Re: DA344-11-2001-Mod-5 Request for Additional Information

Following receipt of the Department's request for additional information issued on 10/12/2025, and a meeting at the Department's Parramatta office on 20/1/2026, Walker Quarries (Walker) and Irwin Environmental Management (IEM) have reviewed our approach to defining the Previously Approved Disturbance Area (PADA) of the Wallerawang Quarry.

The PADA is central to the proposed modification which seeks to reclassify the biodiversity obligations and credits of DA 344-11-2001.

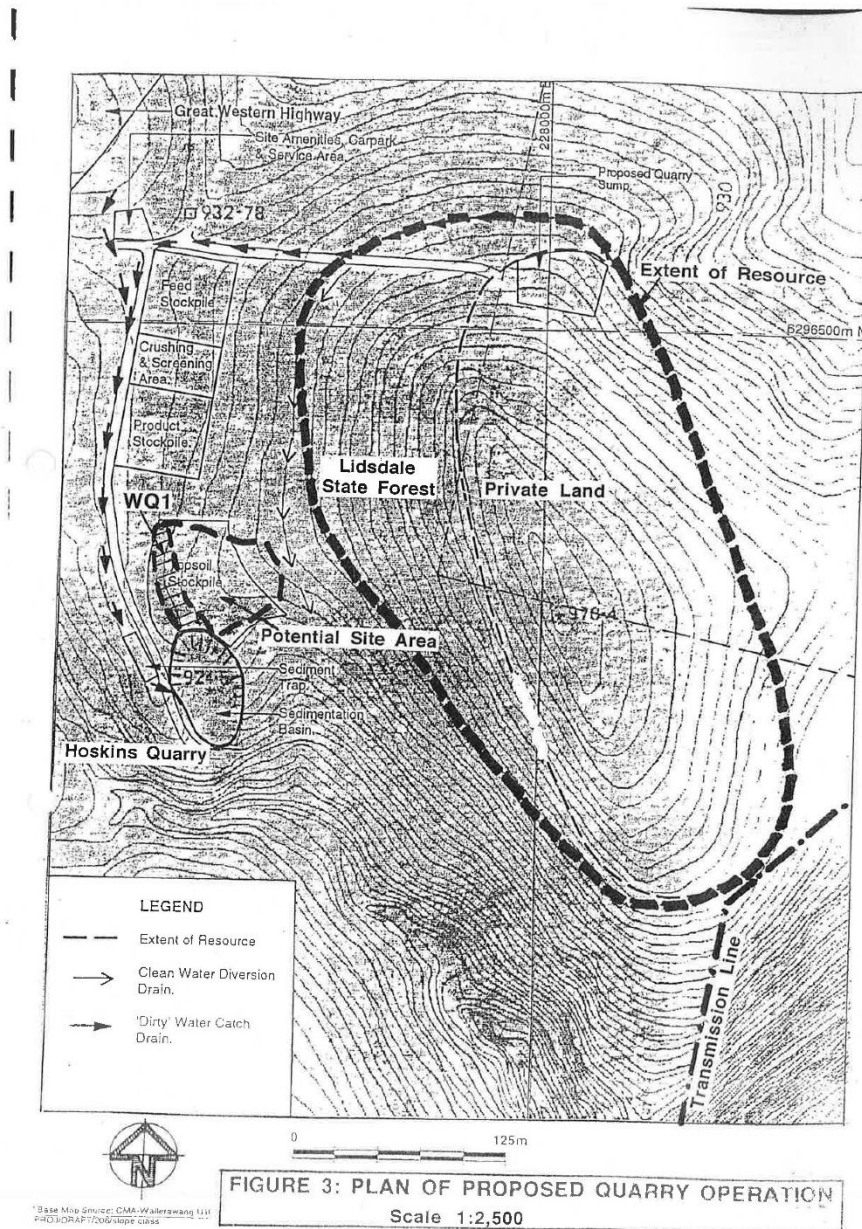
The Department has reviewed the relevant figures and considers that the pit area approved under the original DA344-11-2001 development consent is smaller than presented in Figure 3.2 of the Modification Report (labelled 'Approved Extraction Area – 2004'). Consequently, the Department considers that the area referred to as 'previously approved disturbance area' is over estimated. The signed consent, including figure of the approved pit, is available in Attachment 2.

The Department considers that the western boundary of the pit approved under the original development consent sits approximately halfway between the respective western boundaries of the 'Interpreted Extraction Area (Mod 1)' and the 'Approved Extraction Area – 2004' in Figure 3.2 of the Modification Report. This conclusion is based on the Department's review, which found that the western boundary of the originally approved pit generally follows, and goes no lower in elevation than the 950 metre contour as identified in Figure 2 of the Modification 1 Environmental Assessment, Appendix 6.

Provide evidence demonstrating that the pit area identified as 'Approved Extraction Area – 2004' in Figure 3.2 of the Modification Report is accurate given the originally approved pit under DA344-11-2001, as identified in **Attachment 2**.

- 1.1. The Department makes reference to a figure of the approved pit contained within the original development consent (identified as 'Figure 3: Plan of Proposed Quarry Operation' in *Attachment 1* of the originally issued DA 344-11-2001 – referred to hereafter as *Figure 3* and reproduced below).

- 1.2. With reference to *Figure 3*, it was included in the development consent to identify the site of Aboriginal heritage (as nominated in *Condition 2.44* (of the original consent)) which was to remain undisturbed (see below). It was not included to define the limits of extraction.

- 1.3. Contour values are largely absent on *Figure 3* and the font size of the 'Extent of Resource' line make this less suitable than other figures from the EIS to define the extraction area.
- 1.4. Notably, the 'Extent of Resource' identified on *Figure 3* generally coincides with the extents of the Quarry Development Plans as *Figures 3.4 to 3.8* of the EIS accompanying the development application.

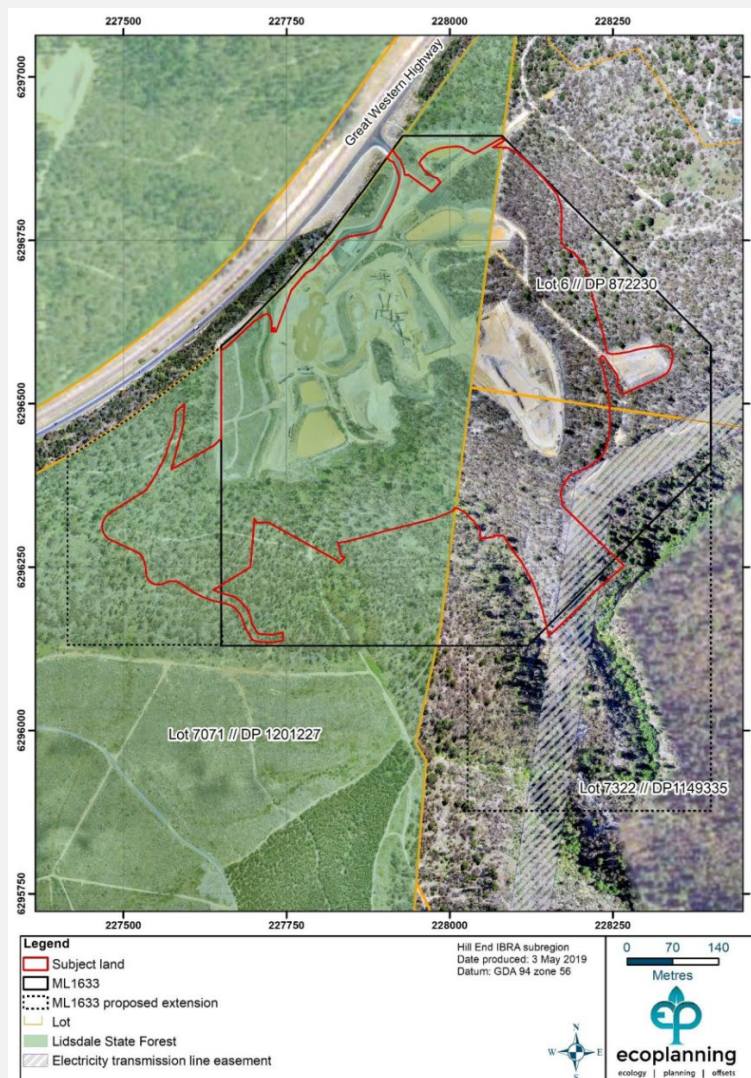
Provide evidence demonstrating that the areas identified as 'External (to Approved MOD3) Credit Calculations – 2019 BDAR' in Figure 3.2 of the Modification Report were unintentionally included in the Modification 3 BDAR subject land and resulting credit obligations.

- 2.1. It is reiterated that the area in question was included in the BDAR credit calculations unintentionally. An area of vegetation to remain undisturbed between the extraction area and a proposed road to the Eastern Stockpile Area was included.
- 2.2. This road defined the 'subject land' of the 2019 BDAR between an existing access road and the Eastern Stockpile Area.
- 2.3. On subsequent review, Walker Quarries notes that this proposed road was neither in place, nor required for the purpose of the Quarry.

Field survey completed on 18 March 2026 has mapped the existing roads of the Mine Site and surrounds (identifiable on aerial photography pre-dating May 2017). It is suggested that the access road to the Eastern Stockpile Area presented in MOD3 incorrectly identified the alignment of the road which follows the northeastern boundary of ML 1633.

- 2.4. Access to the Eastern Stockpile Area is provided either from the extraction area, ML 1633 boundary road or other roads from Lot 6 DP872230 (which service quarry monitoring equipment, residence on Lot 6, the powerline station to south of the extraction area and river frontage).
- 2.5. Clarity was sought from the author of the 2019 BDAR to confirm the area as included in error. In a confirmatory email, the author of the 2019 BDAR, Mr Brian Towle of Ecoplaning Pty Limited made the clarification presented in **Box A** – see next page).
- 2.6. On the basis of Mr Towle's clarification, i.e. no assessed impact to biodiversity within the area beyond the nominated disturbance footprint, the exclusion of this area is justified

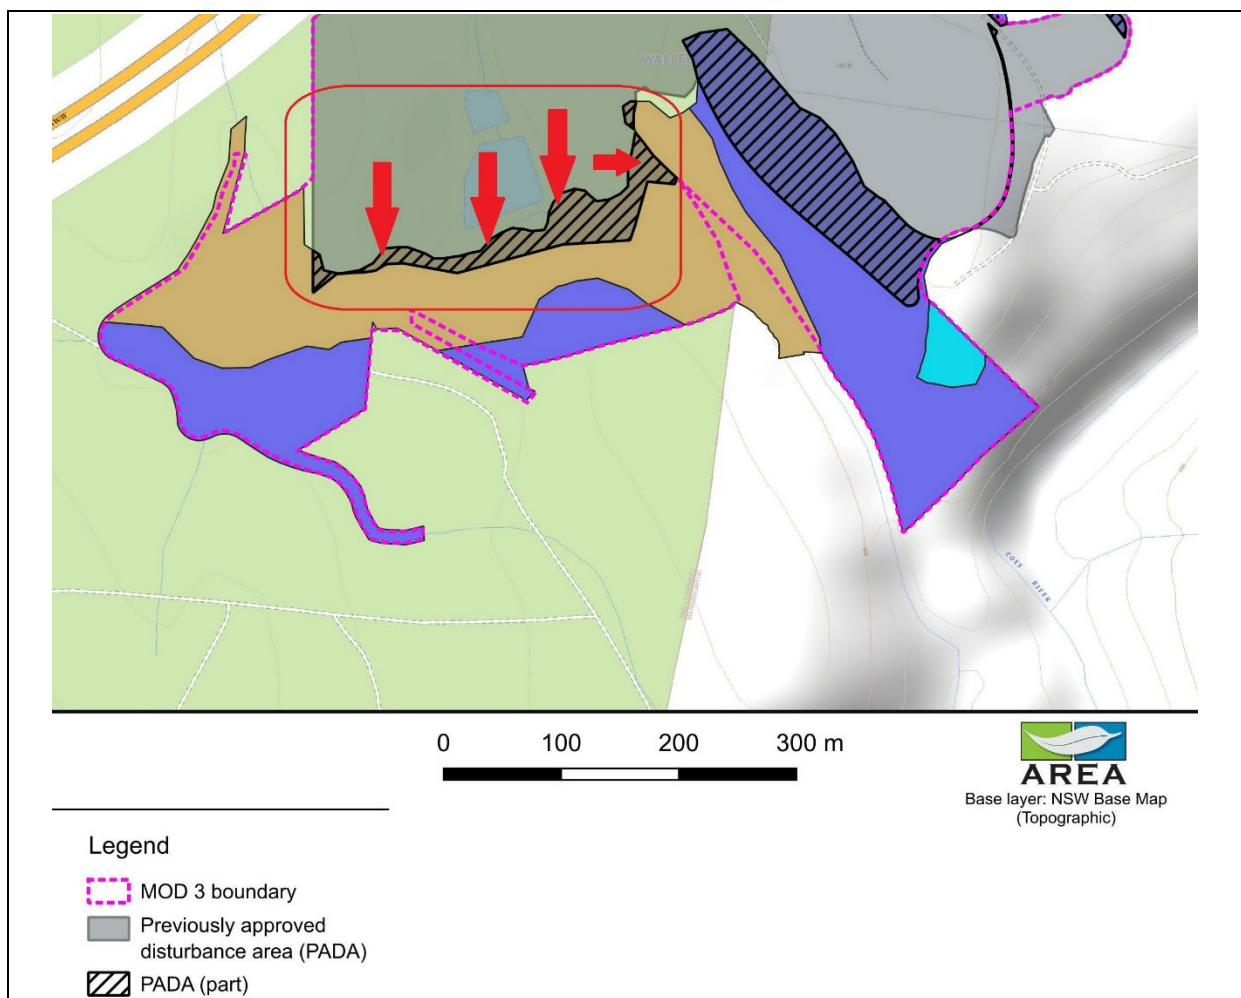
The westernmost area identified as 'PADA (part)' (i.e. associated with PCT 732) in Figure 2-2 of the 19 August AREA Letter Report titled 'correction of biodiversity credit requirements in MOD 3 (to support MOD 4)', does not appear to be associated with the approved disturbance area of DA344-11-2001 prior to Modification 3. I note this area is absent from Figure 3.2 of the Modification Report, and no justification of the inclusion of this area as part of the 'previously approved disturbance area' is provided in the subsequent documentation.

Provide evidence demonstrating that the westernmost area identified as 'PADA (part)' in Figure 2-2 of the 19 August AREA Letter Report, was part of the approved DA344-11-2001 disturbance area prior to Modification 3.

In a meeting with DPHI on 20 January 2026, it was confirmed that the area in question related vegetation mapped to the south of the Main Stockpile Area, SD 1 and Hoskins Quarry (refer below).

- 3.1. On regularisation of the disturbance footprint by Modification 1, disturbance to the southern perimeter of the Main Stockpile Area, Western Stockpile Area, SD1 and Hoskins Quarry, as of May 2017, was approved.

- 3.2. No disturbance boundary was drawn or presented in figures for Modification 1.
- 3.3. Two boundaries were subsequently presented in the 2019 SEE which accompanied Modification 3 as follows.

Figure 4.4: Survey tracks for Purple Copper Butterfly

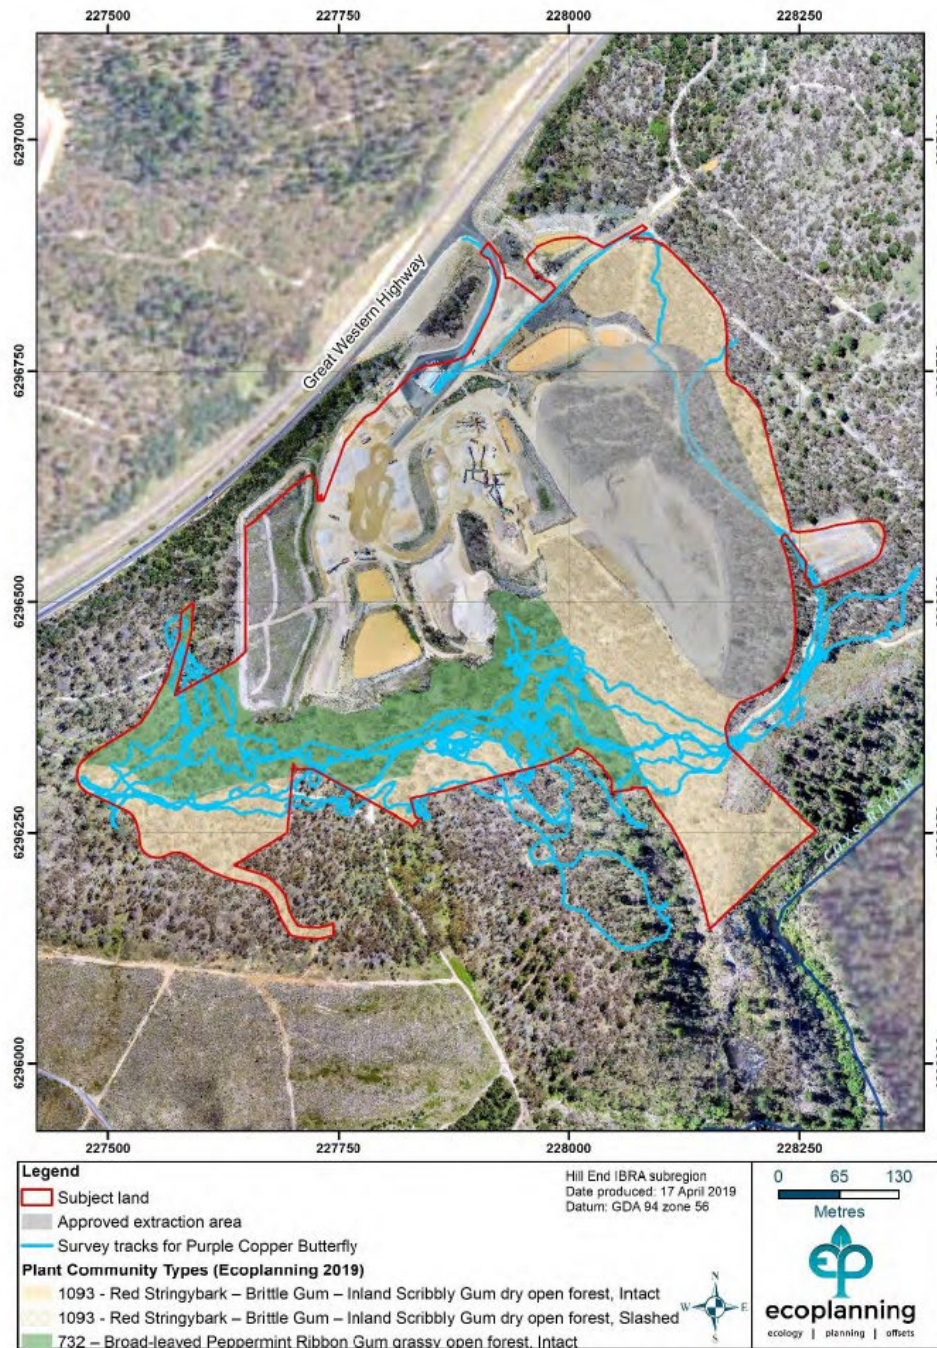
- 3.5. With reference to *Figure 4.4* of the 2019 BDAR (see p.11), the mapping of native vegetation did not follow the polygons nominated by *Figure 2.2A*, i.e. the Development Layout Plan of *Appendix 1* of DA 344-11-2001.

- 3.6. The vegetation mapping of *Figure 4.4* of the 2019 BDAR followed the alignment of native vegetation and included disturbance of this vegetation as part of biodiversity offsetting calculations (Biodiversity Offset Stage B of Condition 28A of DA 344-11-2001).

- 3.9. With reference to the Department's query, it is accepted that the native vegetation present at the time of the 2019 BDAR, i.e. as mapped in 2019, should be included in calculations for biodiversity offsetting regardless of whether it occurs within the Approved Disturbance layer of *Figure 2.2A*.

PLAN: Corrected EIS Extraction Area for PADA
Identification and comparison of identified intersection points between extraction area perimeter and surface contours over contemporary survey plan.
- For information and Review Only (Not For Publication) -
WALLERAWANG QUARRY, WALLERAWANG NSW 2845

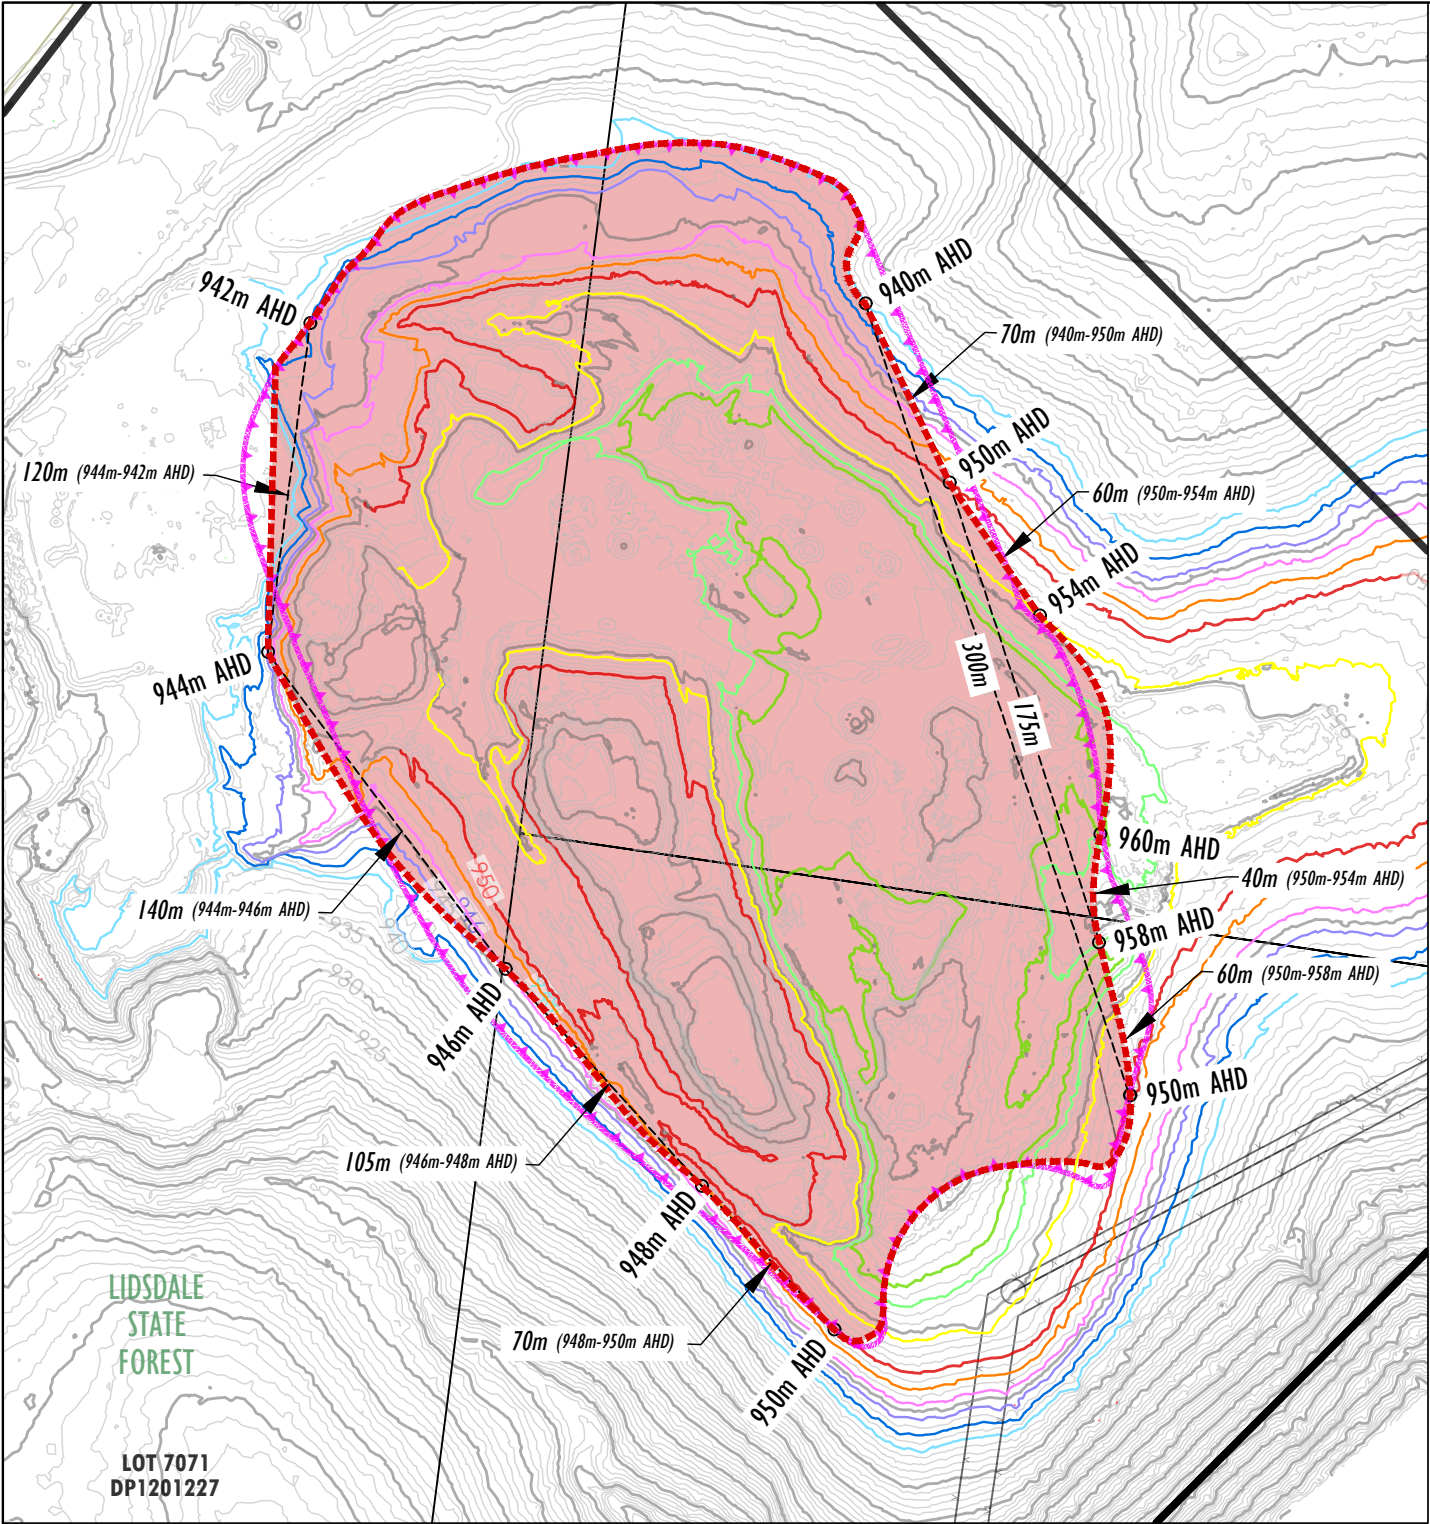
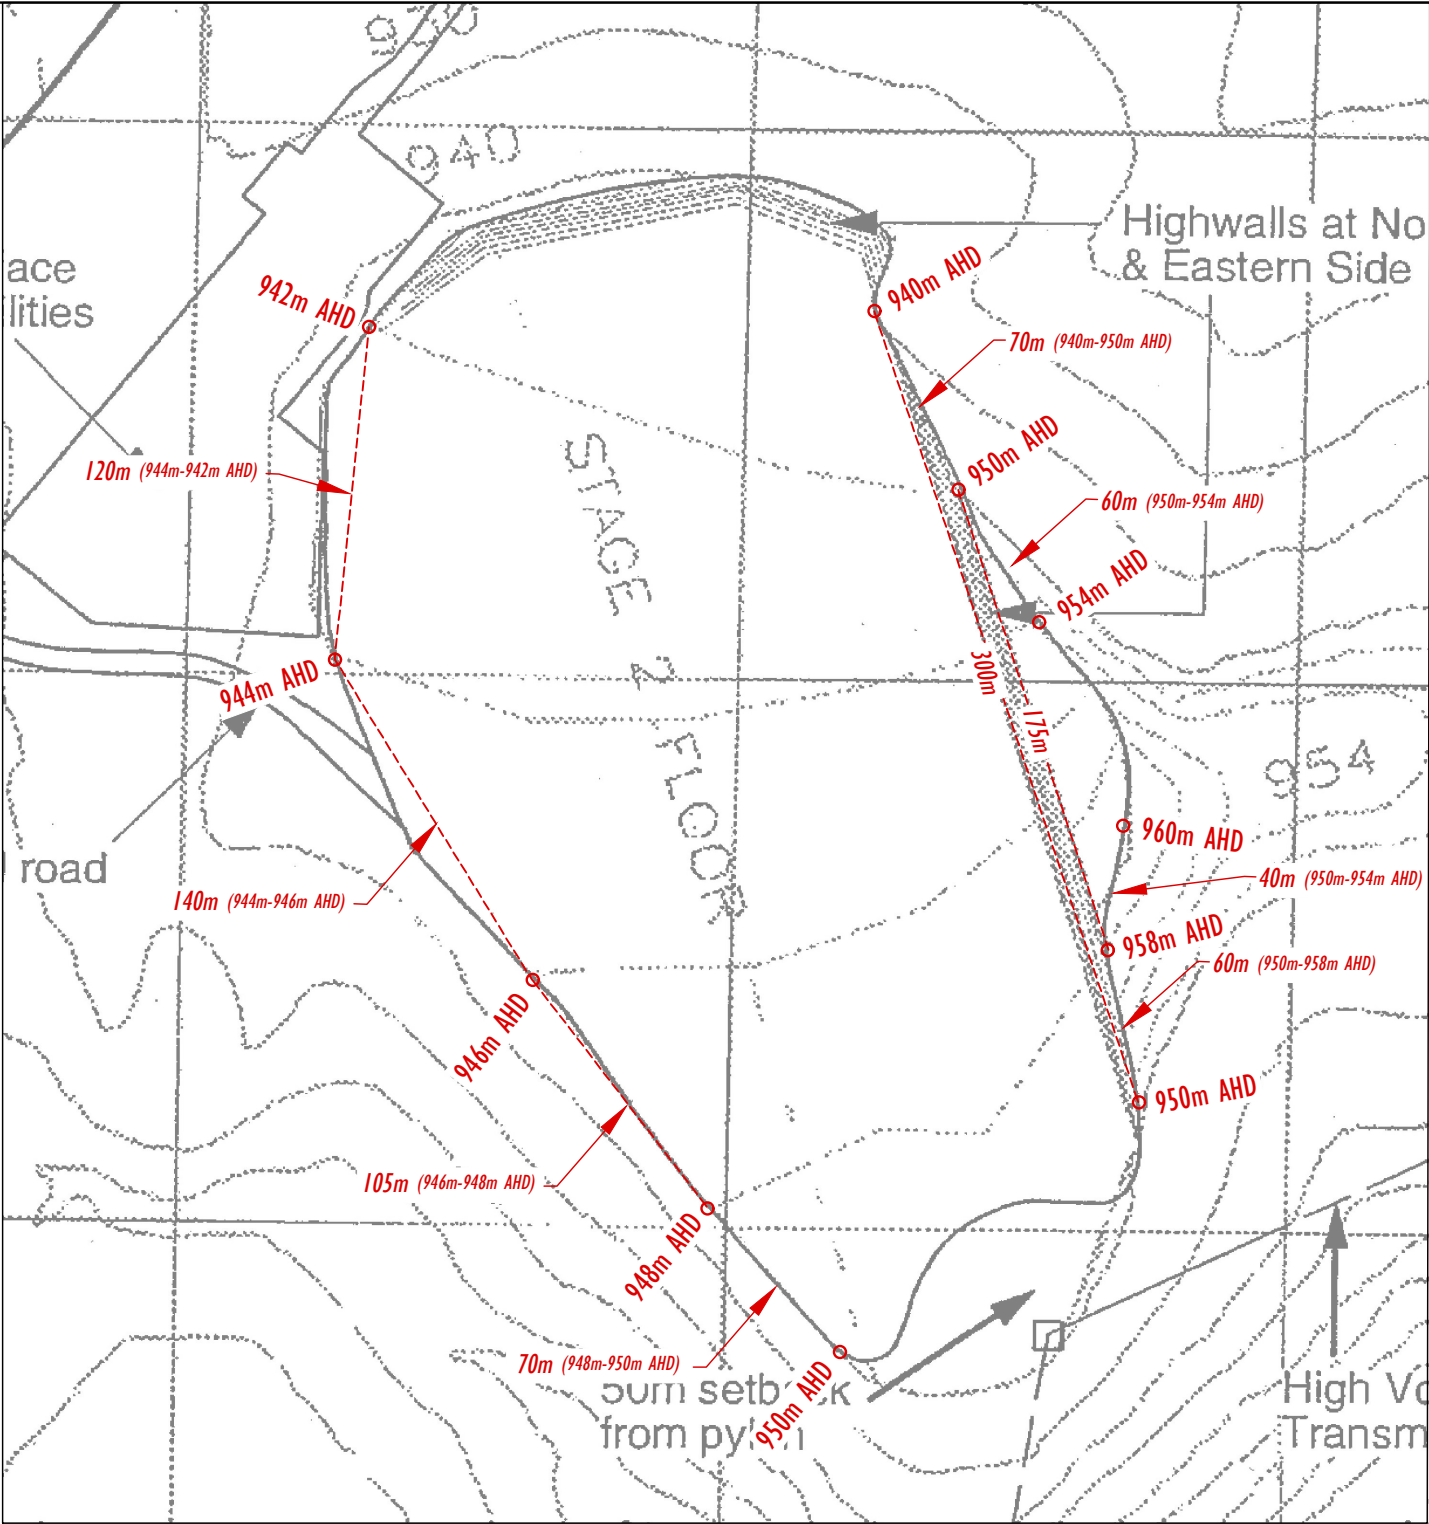
- 1.10. Consultant surveyors CEH have remapped the intersection points and distances derived from *Figure 3.7* over contemporary survey of surface contours (refer to **Attachment A**). The critical intersection points and calculated distance between these are identified to illustrate the accuracy of the updated overlay.

- 1.11. **Attachment A** also includes the ‘corrected’ perimeter of the 2001 EIS extraction area against that used to derive the PADA for MOD 4. The following minor deviations from the extraction area as identified as PADA have been identified.

- 1.11.1. Towards the northeastern corner, *Figure 3.7* shows the extraction area following the 940 m contour line. This was later regularised (by Modification 1) to create a straight line perimeter of the pit.

As this area falls within the limits of the approved extraction area identified as part of the MOD 1 regularisation, no change to the PADA is required to account for this discrepancy.
 - 1.11.2. Against the northwestern corner of the extraction area where the EIS defined extraction area is not as rounded as presented in subsequent assessment.

This area falls within the regularised disturbance footprint of the Quarry (MOD 1) and therefore no change to the PADA is required to account for this discrepancy.
 - 1.11.3. In the southeastern corner of the extraction area, the alignment of the extraction area is straighter in a north-south alignment than the previously identified alignment which followed the 950 m contour.

Modification to the PADA is required, however, the current disturbance footprint is contained by the limits of the extraction area defined as part of the MOD 1 - MOD 3 assessments and therefore no additional disturbance to biodiversity requires assessment.
 - 1.11.4. Along the western perimeter of the extraction area, the fall from the 950 m to 942 m contour is more gradual in *Figure 3.7* than nominated in the PADA of MOD 4.

A small area was therefore incorrectly included in the MOD 4 PADA and has been corrected to allow for redefining of offset stages and biodiversity credits.
